KELLER SPRINGS LOFTS

LOFT APARTMENTS IN ADDISON, TEXAS

To: Jordan & Skala Engineers, Inc. RFI #: 16
14240 Midway Road, Suite 350 Date: 12/28/2011
Dallas, TX 75244 Job: EB-02 Keller Springs Lofts
Ph: 469/385-1616 Fax: 469/385-1615 Phone: 877-777-5115

SHEET NUMBER
E-10.1

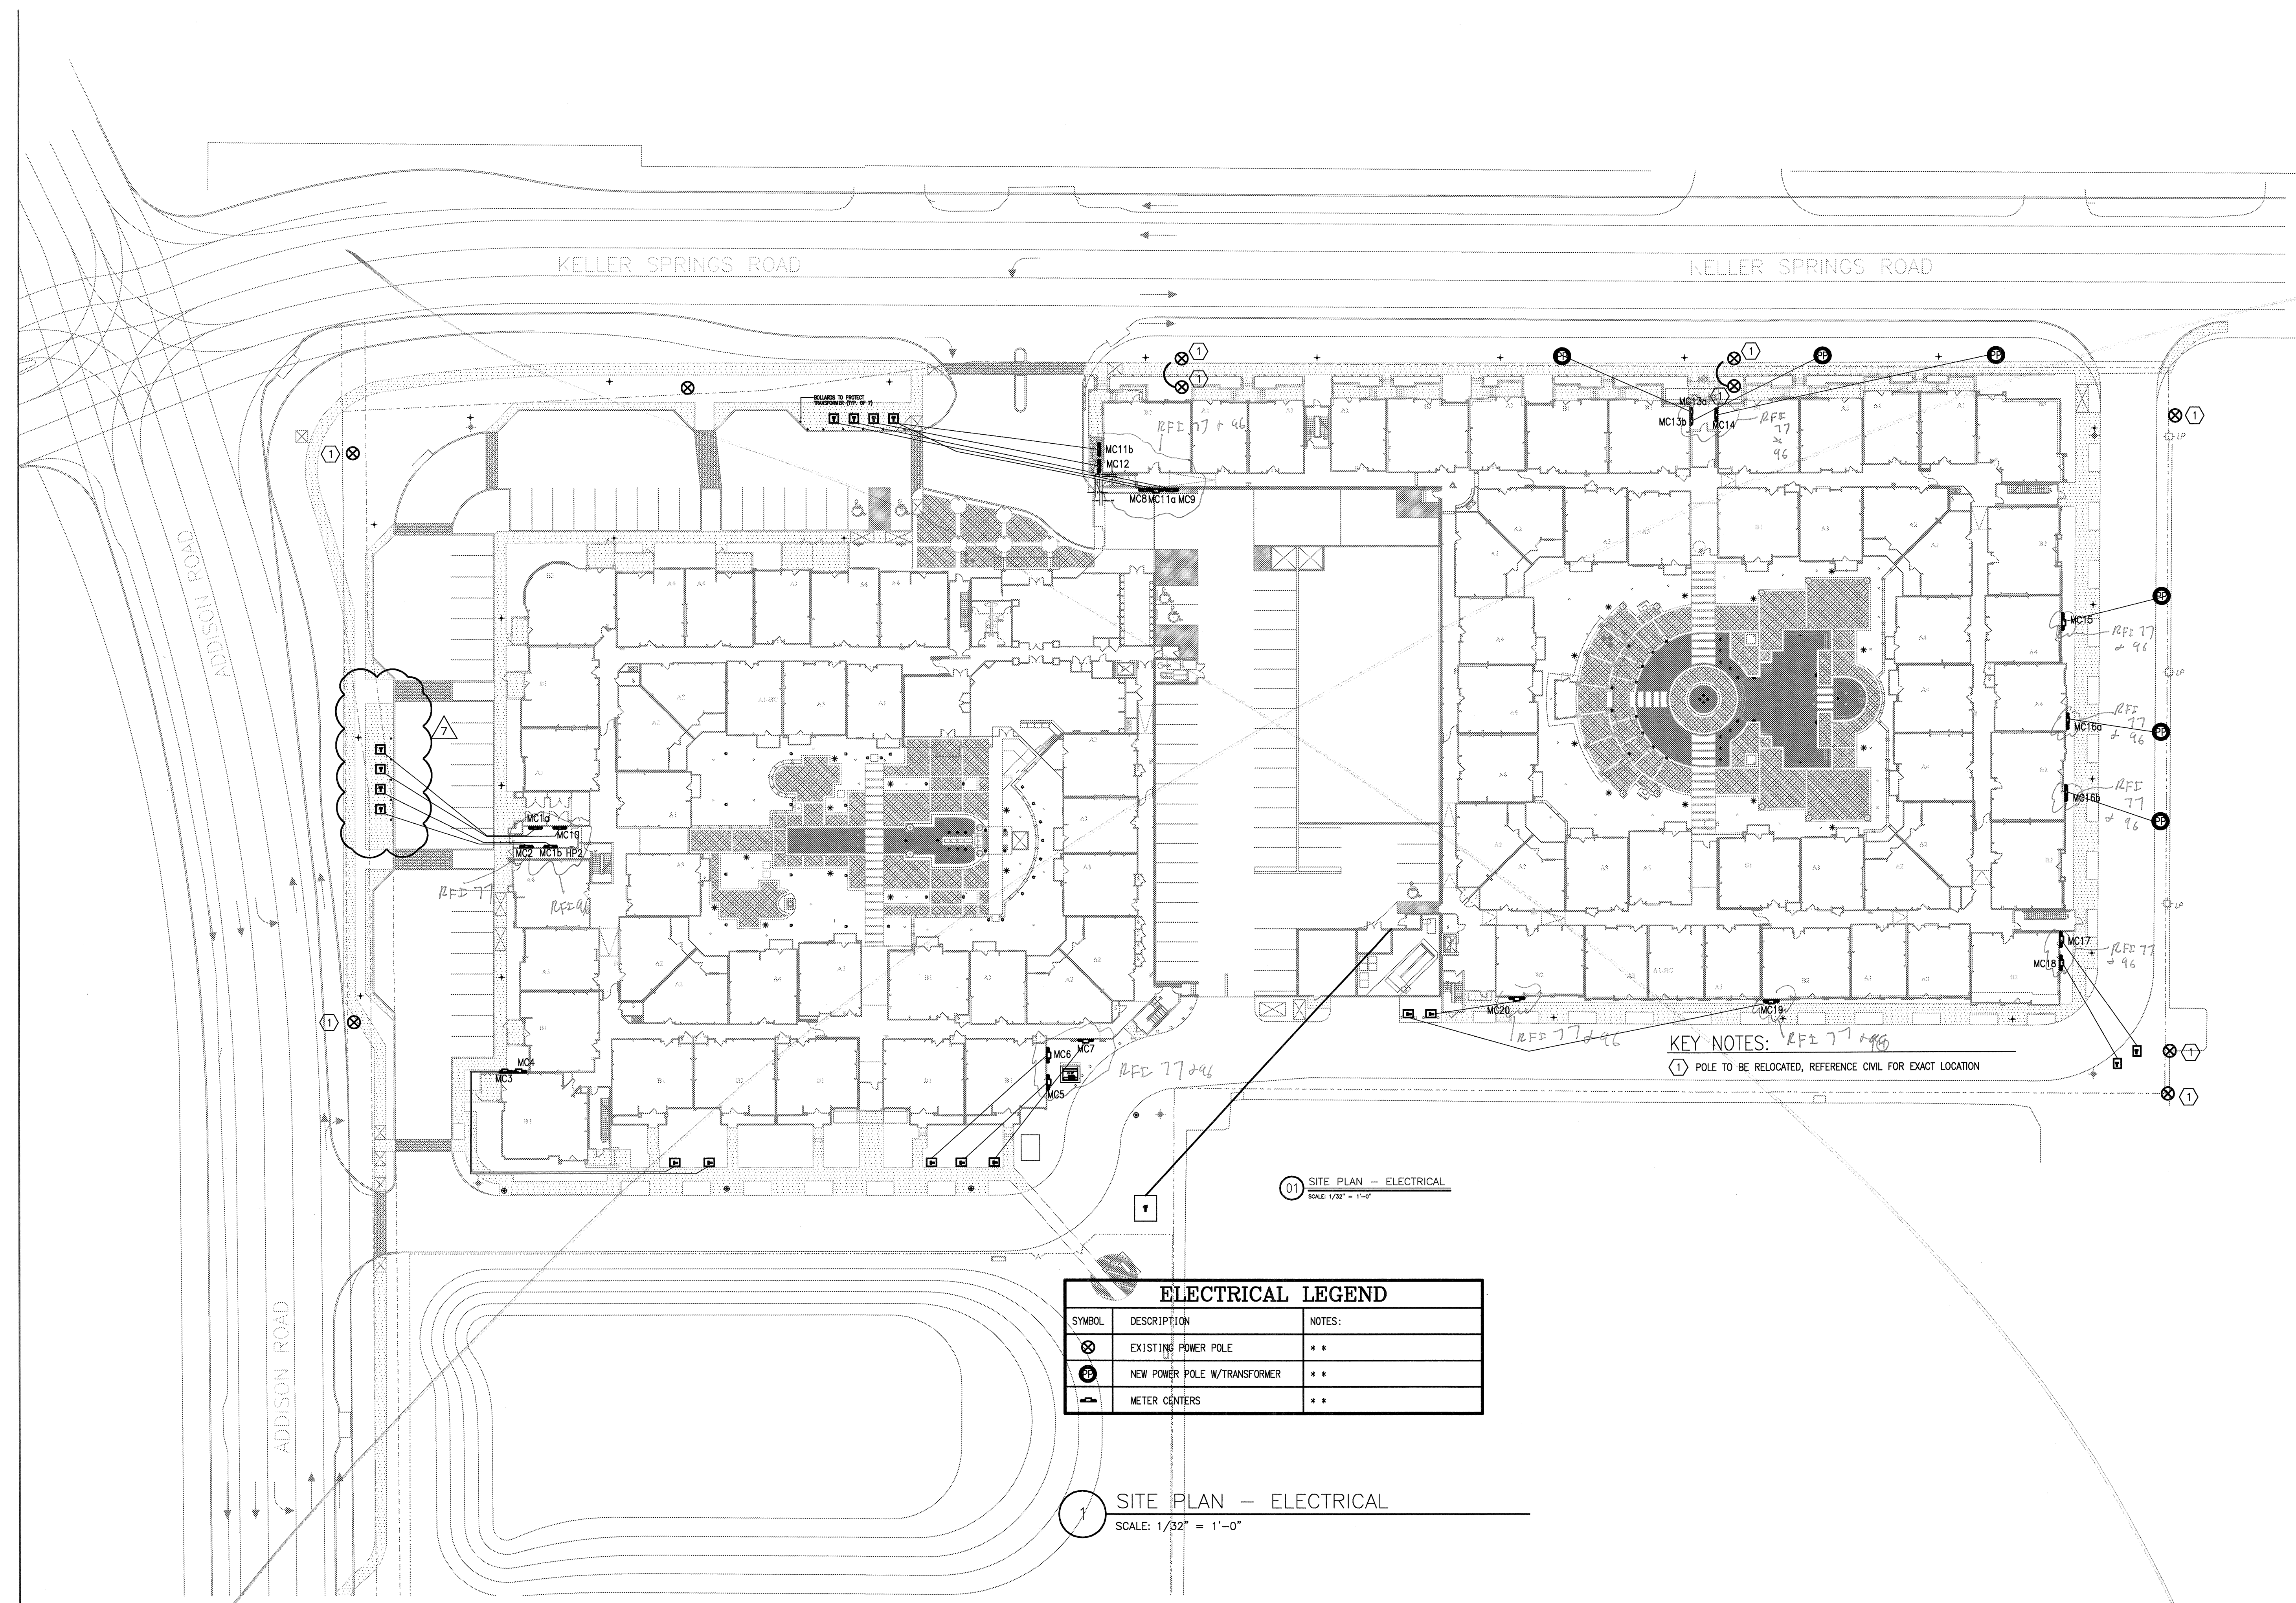
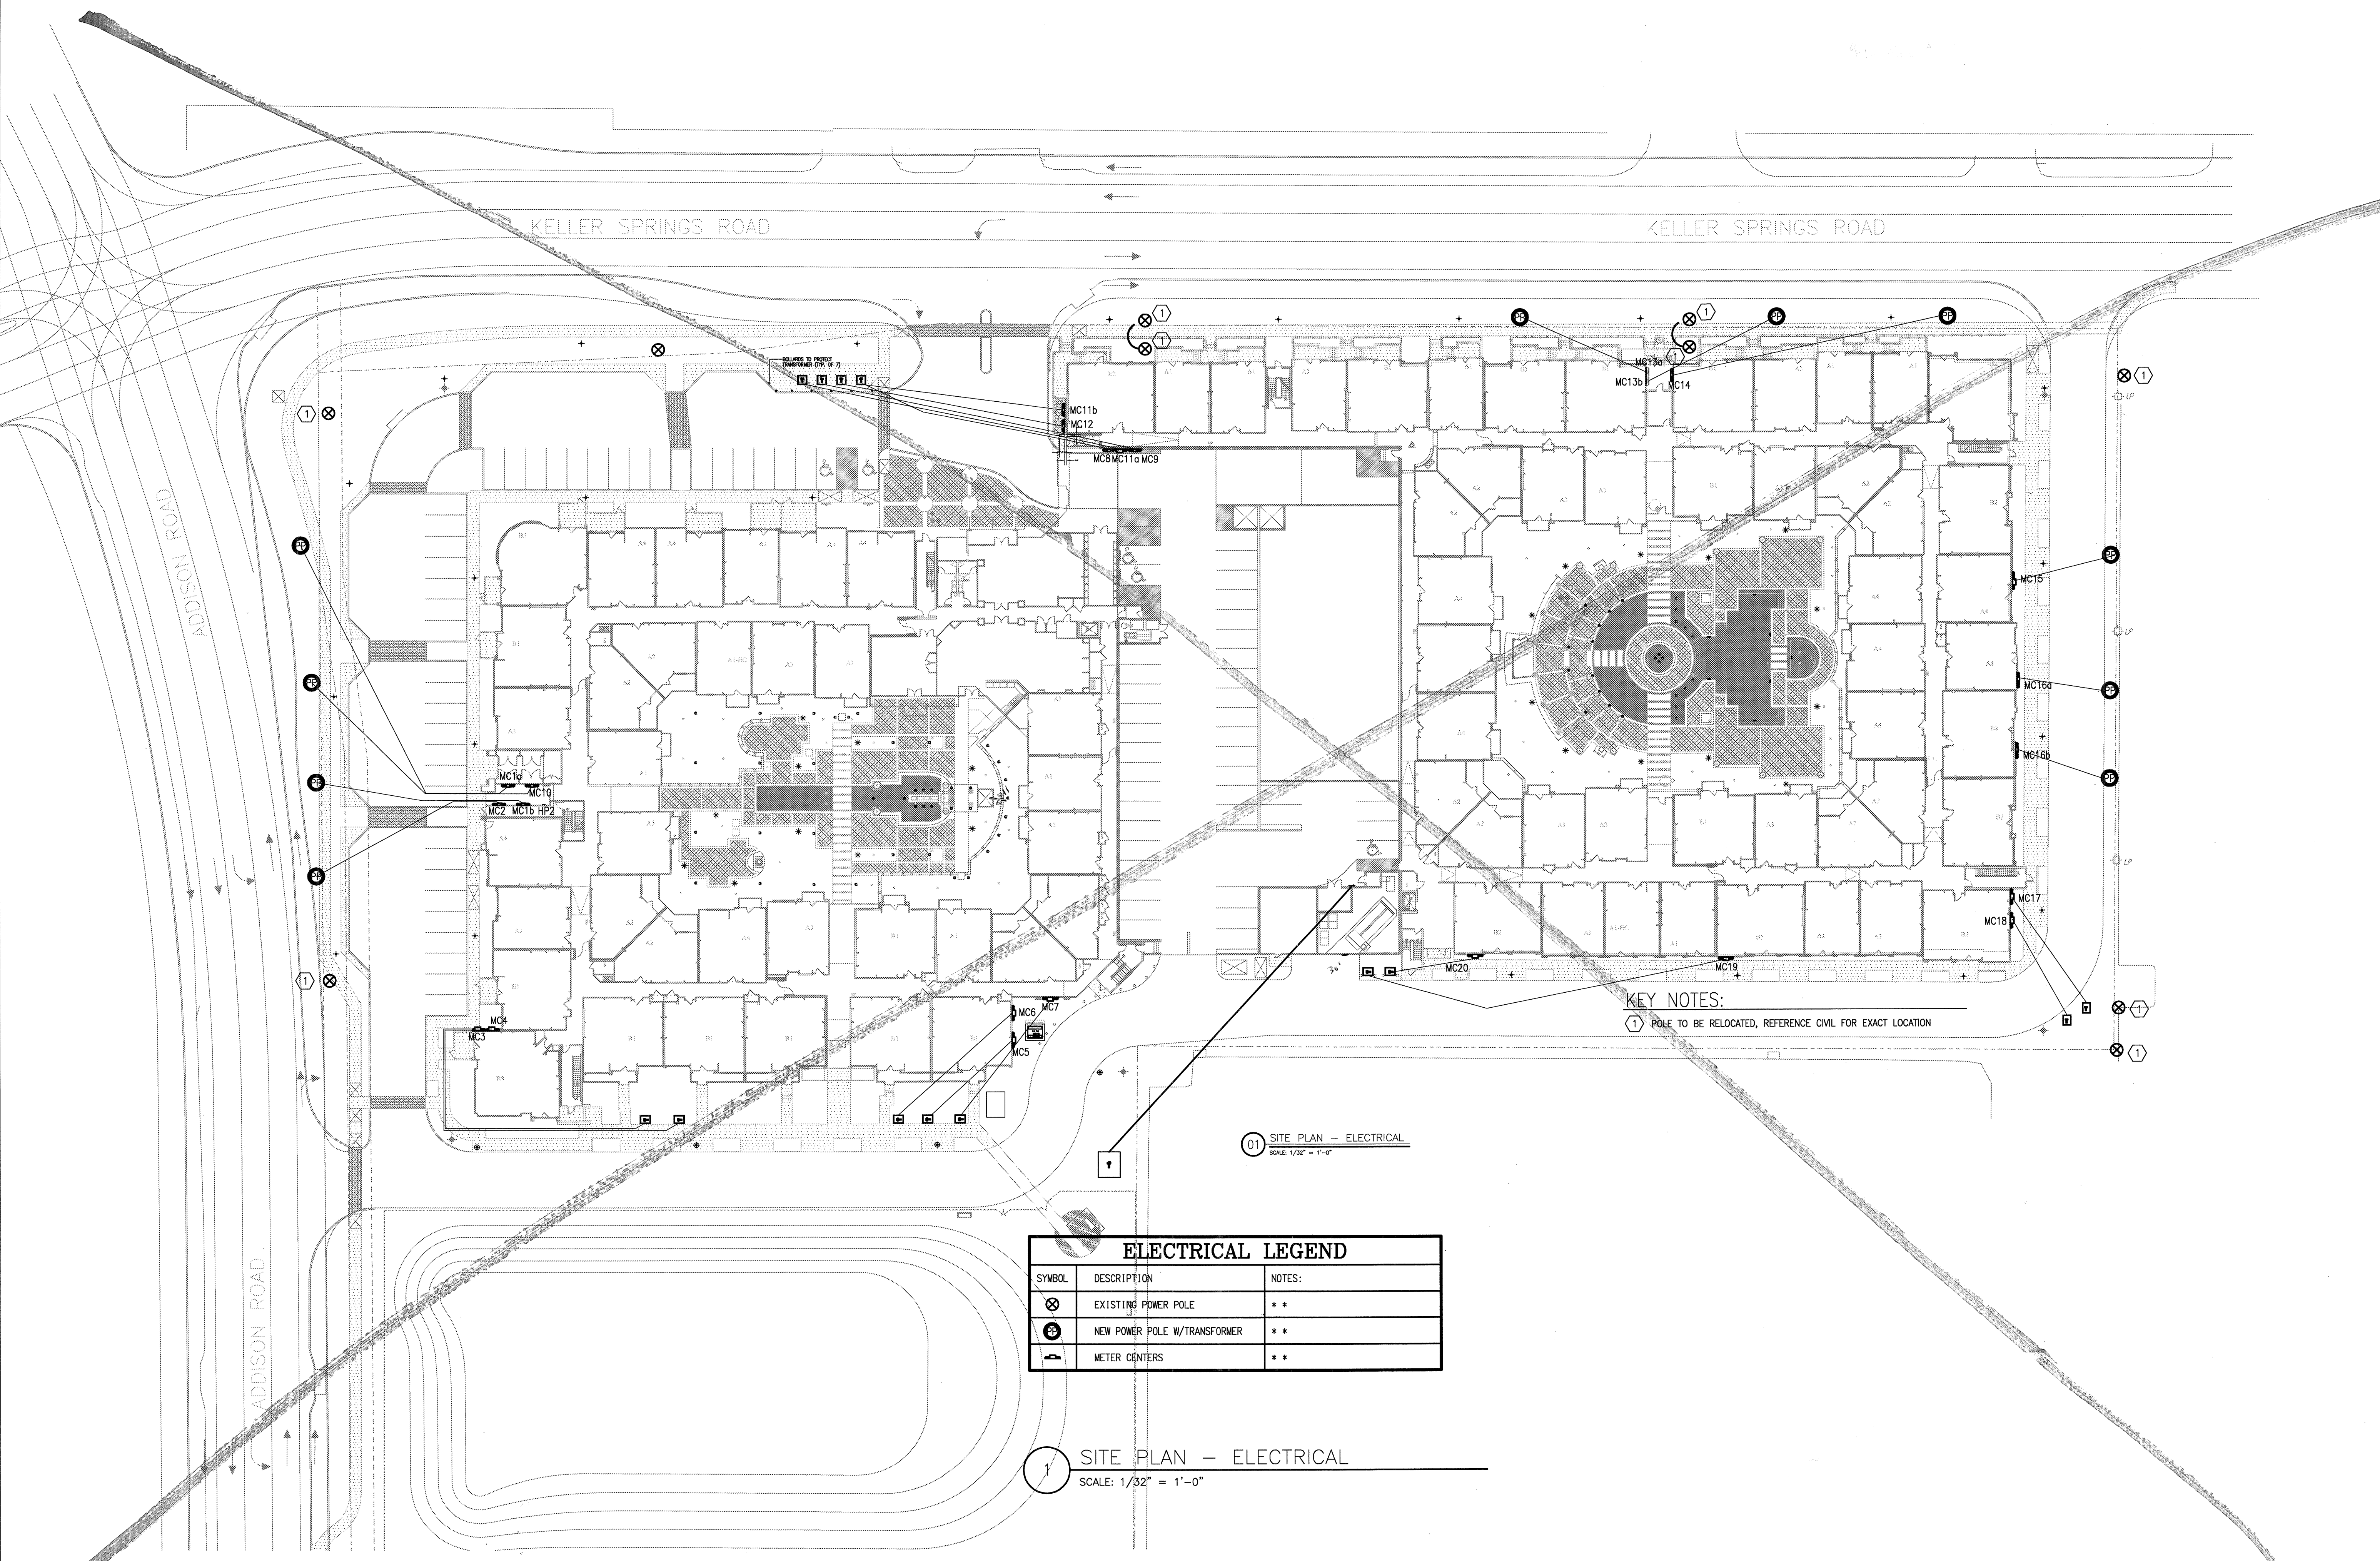
Request:
 Some of the meter centers have changed location and numbers. 3.1C in Architectural and E-3.1C have different meter center numbers than the final E-10.1 and oncor final drawing. Also, E-10.1 and Oncor show two meter centers inside the garage. This must be a mistake. The meter centers should be mounted to the exterior of the building as shown on 3.1C and E-3.1C. I think we may want to have the meter center numbers match the Oncor plans and change from 3.1C and E-3.1C. These conflicts are very confusing and need to be corrected so we get them in the right place. Please see attachments and advise.

Request:
 Please see the attached Oncor Construction Print. The following Meter Center locations do not match up with Oncor's layout. E3.1A - MC1B and MC2 are reversed from Oncor plan. These meter centers are also in the wrong location on E10.1. E3.1C - MC3, MC1A, MC1B and MC12 are different from Oncor plan. MC9 is OK. E10.1 also needs to match up with the Oncor plan. Please revise plans to match the Oncor layout.
